UNITED STATES PATENT AND TRADEMARK OFFICE

APPLICATION NO.	FILING DATE	FIRST NAMED INVENTOR	ATTORNEY DOCKET NO.	CONFIRMATION NO.
10/009,363	03/21/2002	Hiroko Matsunaga	NITT.0049	5840

Office Action Summary

DETAILED ACTION

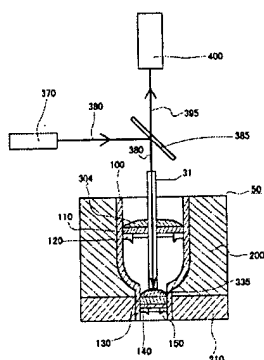
As already discussed in the previous Office Action, the gene analyzer of Kuhara et al. comprises an upper and a lower opening, connected by a channel comprising: a) waterproof

2 comprising at least two or more of a porous membrane upper layer 2a and a porous membrane lower layer 2b, differing in material, wherein said material is disclosed as functioning as a filter membrane (Solution section in the provided translation of the publication, see image reproduced).

Clearly, the gene analyzing of Kuhara et al. comprises three filters arranged in sequence as claimed in the instant claims.
